RE: Crossing Trails Destination Resort

Planning Addendum #1 - Responses to Incompleteness Letter

This addendum is in response to the February 25th, 2022 Letter of Incompleteness issued by the Crook County Planning Department regarding the Crossing Trails Destination Resort Application (DR-08-0092).

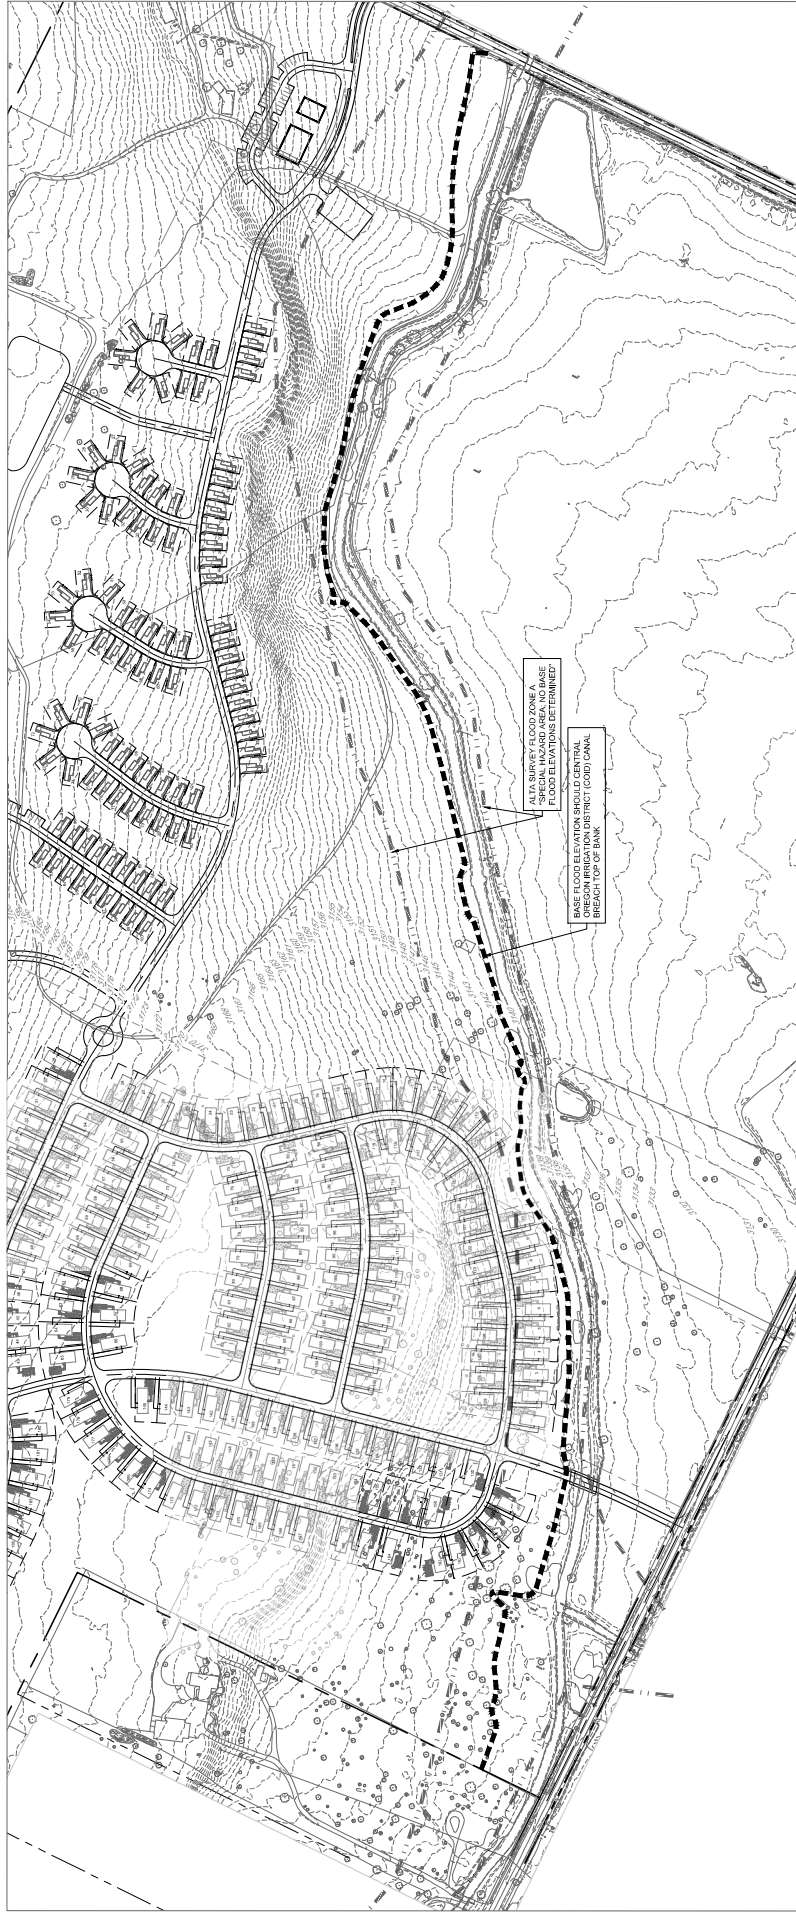
Staff Comment: *The above code section only allows “alterations and nonresidential development uses” within the 100-year floodplain. The narrative statement submitted with the application indicates “[b]ridges, canal crossings and pathways are the only improvements anticipated in this area.” However, the “Conceptual Layout C5” submitted with the application shows several “Vacation Villas” located at least partially within the 100-year floodplain. The Applicant needs to provide additional explanation as to how such lots are in compliance with CCC 18.116.040(12).*

Additionally, staff was unable to find a geotechnical report demonstrating adequate soil stability and mitigation measures designed to mitigate adverse environmental effects from improvements in the floodplain. The Applicant should provide such report or explain why it is not necessary.

In response to the mapping discrepancies, the Applicant's design team has prepared an exhibit that more precisely depicts the extents of the 100 year floodplain (assuming this feature is actually capable of flooding). Refer to Attachment #1 – Flood Exhibit. This has been signed and certified by a registered civil engineer in the State of Oregon. Since no development is being proposed within the floodplain, no geotechnical report is necessary.

The Applicant's original statement that the "bridges, canal crossings and pathways amenities are the only improvements anticipated in the 100 floodplain" is still valid. None of the "Vacation Villas" will be located within the 100-year floodplain.

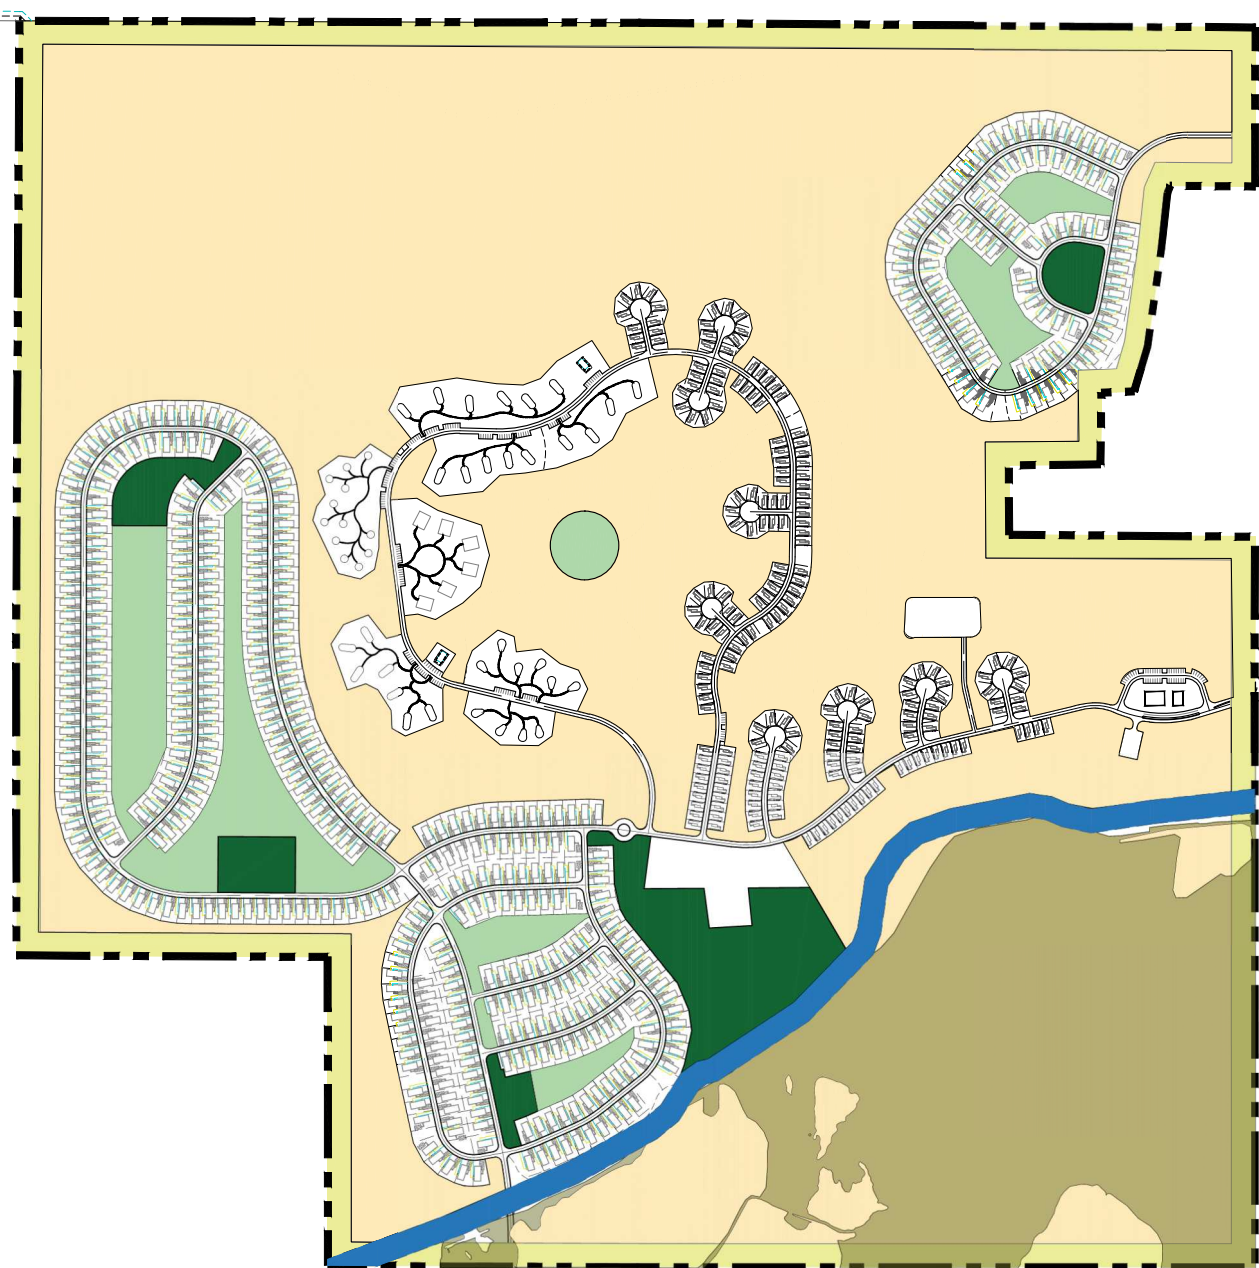
Staff Comment: *Staff requests a map with labels and acreages depicting the approximate location of open space, buffer area, or common area, to confirm the proposed development plan complies with CCC 18.116.0808(3)(a)(vii).*

Applicant’s Supplement: Based on a 581 +/- acre resort property, a minimum of 50% or 291 acres is required to be maintained as open space within the proposed Crossing Trails Resort.

As illustrated on the conceptual Open Space Plan , approximately 75% of the property would be considered open space.

The land devoted to open space is illustrated on the conceptual Open Space Plan. Refer to Attachment #2 – Open Space Plan.

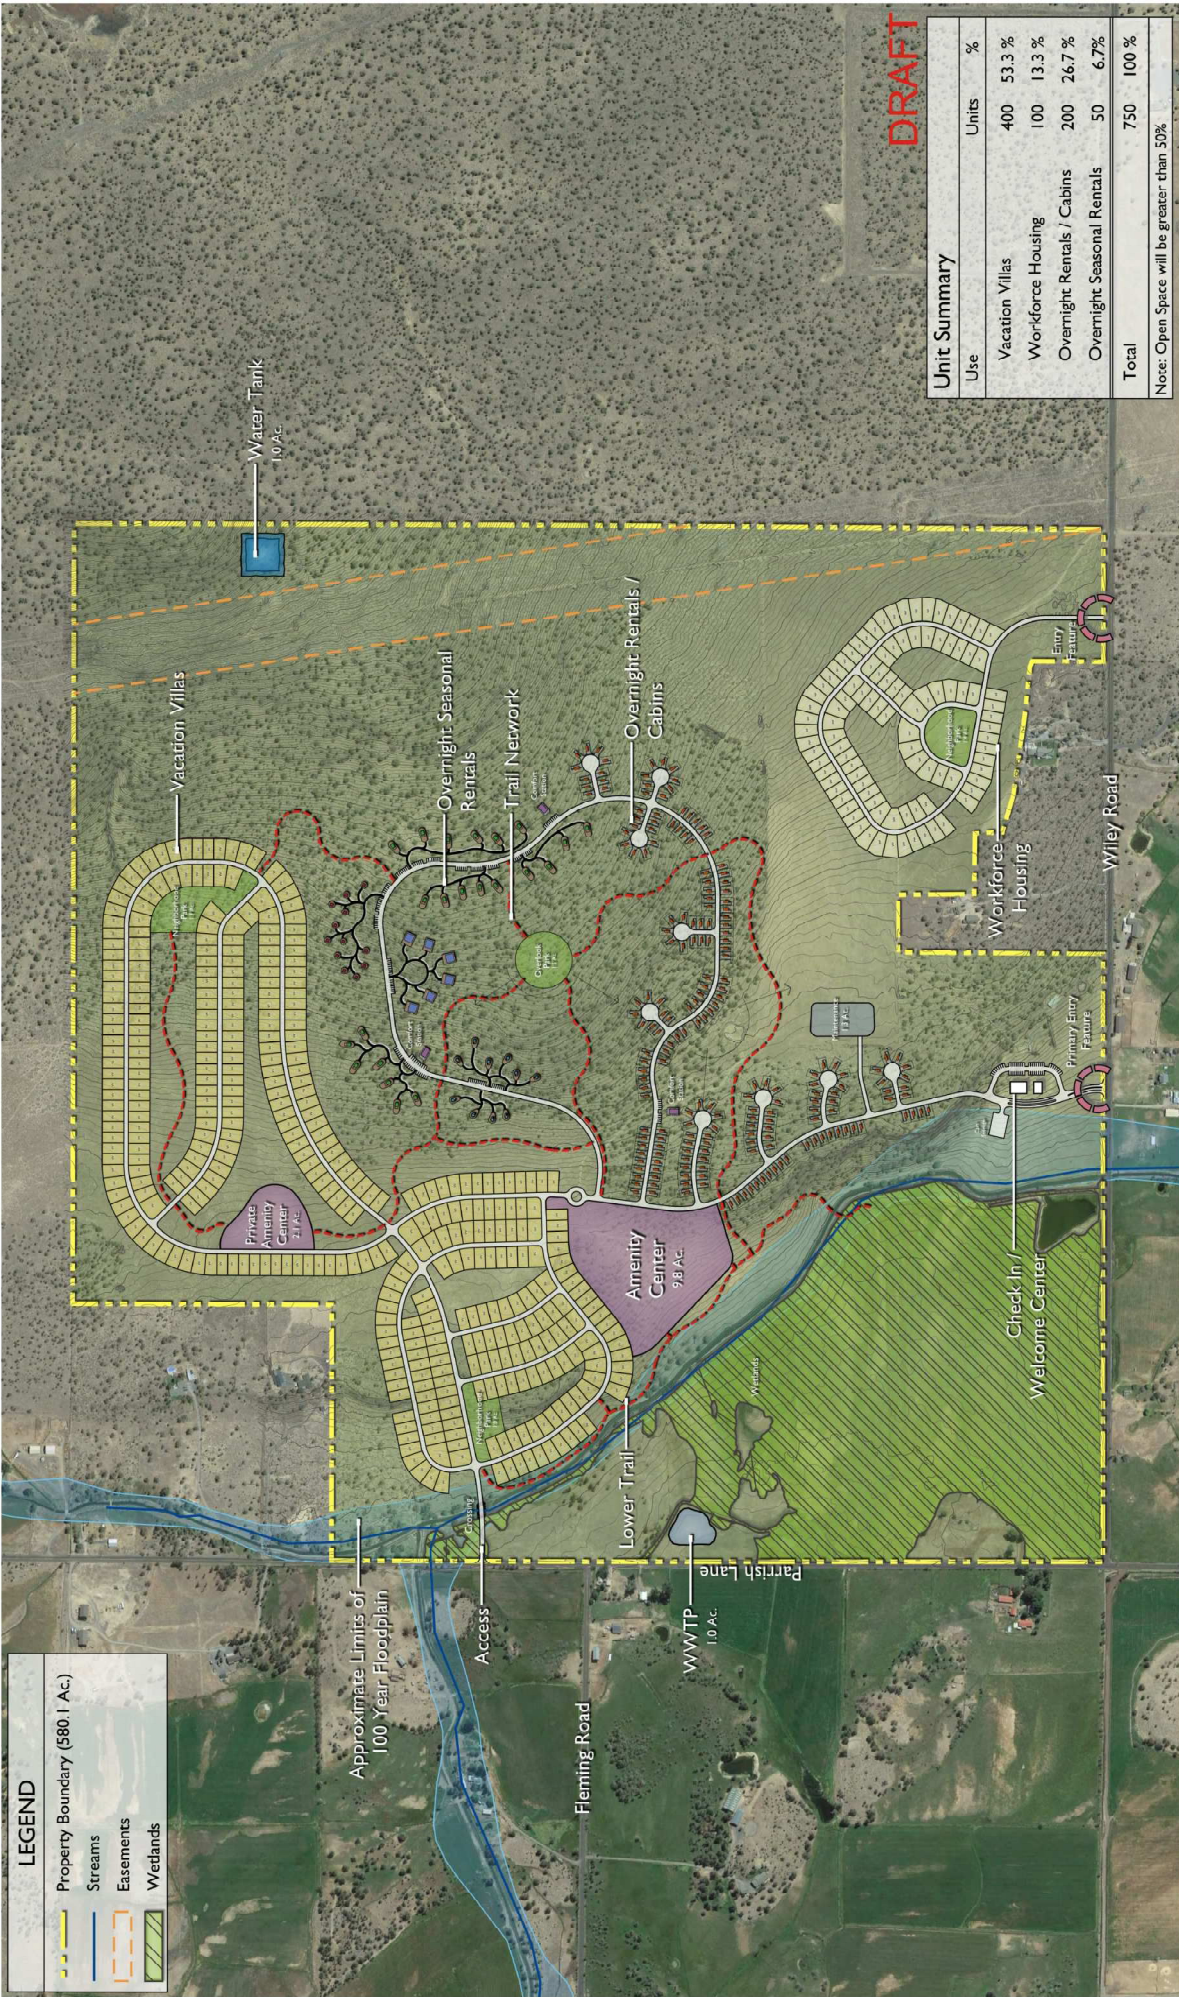
Staff Comment: *In Applicant's narrative, on page B-65, it indicates that its concept plan indicates an area for overnight lodging units and that Applicant is considering a recreational vehicle (RV) park. Staff notes that RV parks do not qualify as overnight lodging units. See CCC 18.116.030(5). Staff asks Applicant to supplement its narrative to clarify its intent.*

An RV park was identified as a possible future use and is not currently be contemplated as part of the proposed modification request.

An updated illustrative plan has been prepared to eliminates the reference to this potential future use. Refer to Attachment #9.
